CITY OF ALBUQUERQUE

**RE: Alameda Development
6100 Alameda NE
Conceptual Grading and Drainage Plan
Engineer's Stamp Date: 08/16/18
Hydrology File: C18D086**

DRAINAGE AND TRANSPORTATION INFORMATION SHEET (REV 6/2018)

Conceptual
Grading Plan
date:
8-17-18
sheet:
3

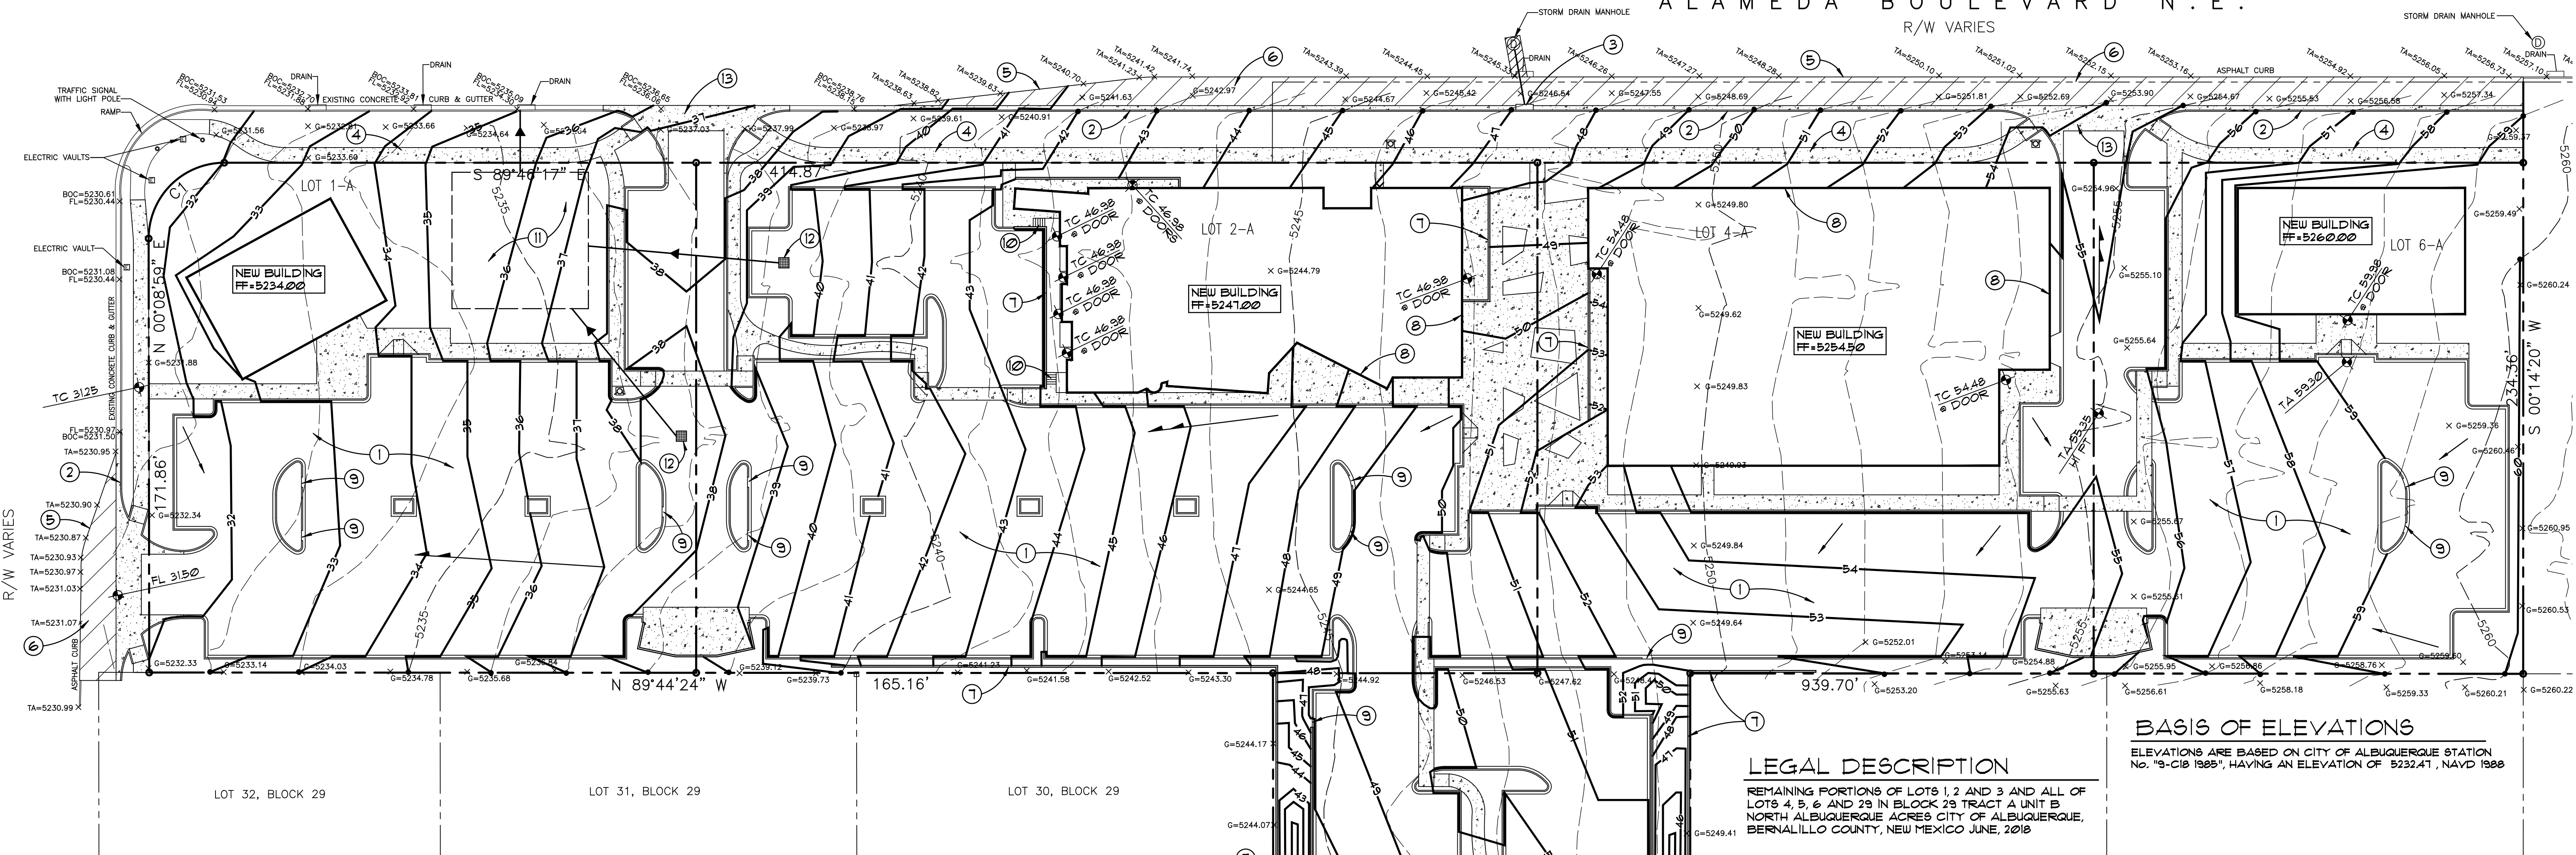
1. Please add a note stating "Not for Construction".
2. Please submit a drainage report for this project.
3. Please provide the FIRM Map and flood plain note with effective date.

4. Please add a note that this site is within the North Albuquerque Acres Master Drainage Plan and with a design analysis report "Alameda Blvd San Pedro to Wyoming Project #7663.91 by Thompson Engineering dated January 2012, the allowable discharge for this site is 3.82 cfs/ac.

5. Please provide a drainage map showing the discharge points, acres going to these, and the discharge.
6. The site cannot freely discharge to San Pedro Blvd. According to the report outlined in #4, the site discharges into the existing storm sewer system in Alameda Blvd.

7. Please add a water block at the entrance to San Pedro Blvd.
8. Please add inlets to the parking area adjacent to San Pedro and discharge this to the underground storage tank.

9. Please show downstream capacity for the discharge into Signal Ave.
